**From:** [Paul Nietfeld](#)  
**To:** [Benton County Talks Trash](#)  
**Cc:** [samimperati@icmresolutions.com](mailto:samimperati@icmresolutions.com)  
**Subject:** Citizen input for Workgroup meeting Sep. 15  
**Date:** Monday, September 12, 2022 9:26:01 PM  
**Attachments:** [Nietfeld comment input Workgoup Meeting2 15Sep2022.pdf](#)

## Coffin Butte: Intake Volume History

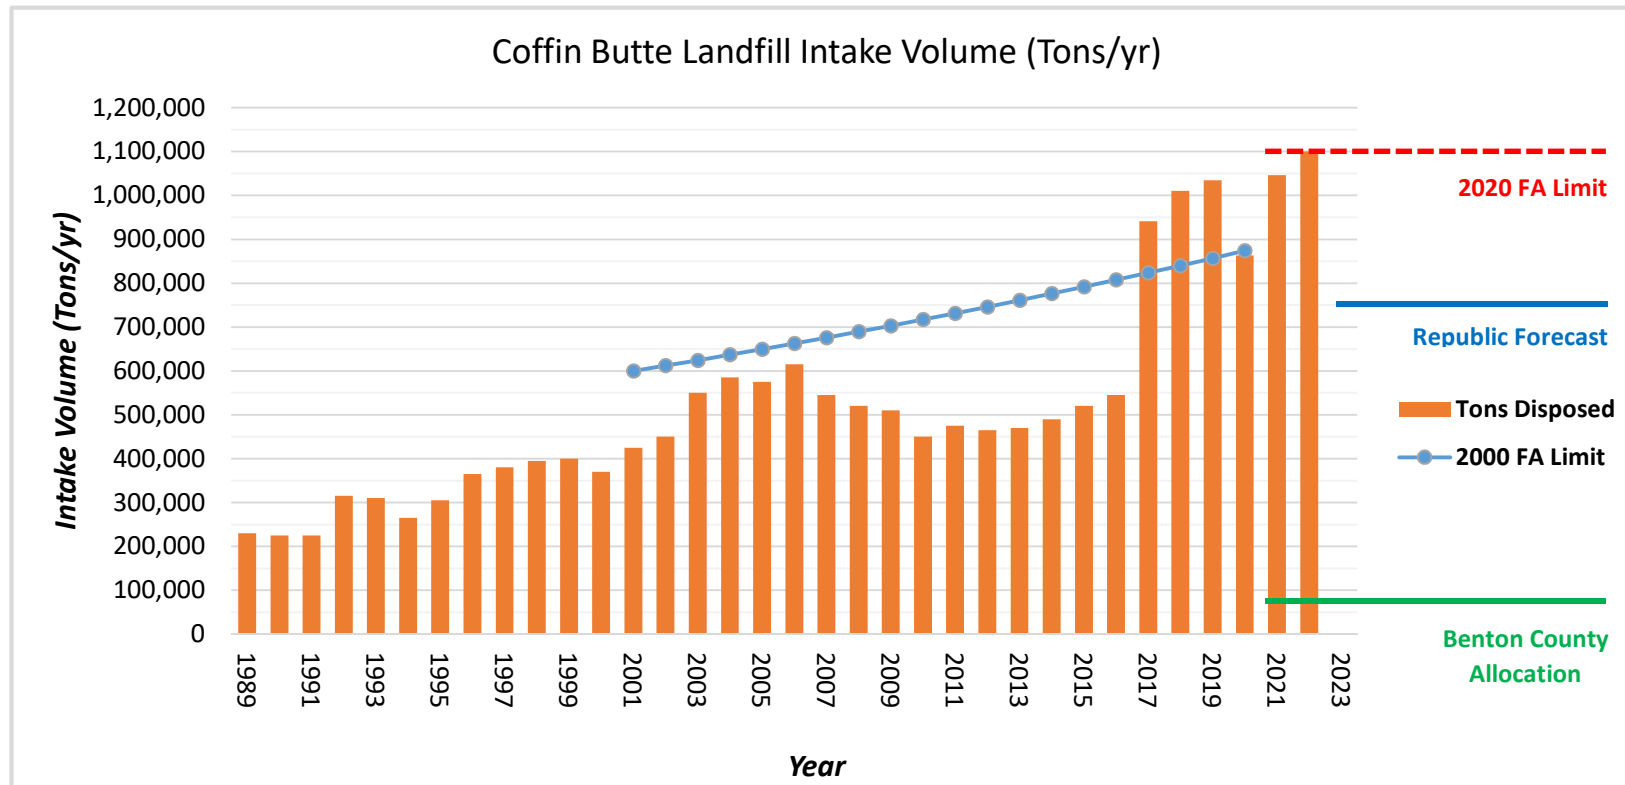
- Large-scale industrial operation: 1.1 M Tons/year => 7,000,000 lbs/day, 6 days/week
- Dramatic growth starting in 2017 – *What happened to cause and sustain this?*
- The 2000 Franchise Agreement intake limit was violated in years 2017–2019 – *Why no County action?*
- 2022 volume is estimated from first half 2022 filings with DEQ.
- Recent years show sustained high demand for landfill volume – *Does Republic plan to maintain this level?*
- Even a 5,000,000 cubic yard expansion cell would fill in less than 5 years at the current intake rate

**This plot shows why we (workgroup, staff, administration, the public and the franchisee) are here: Large intake volume in the last 6 years is quickly depleting the available Cell 5 volume.**
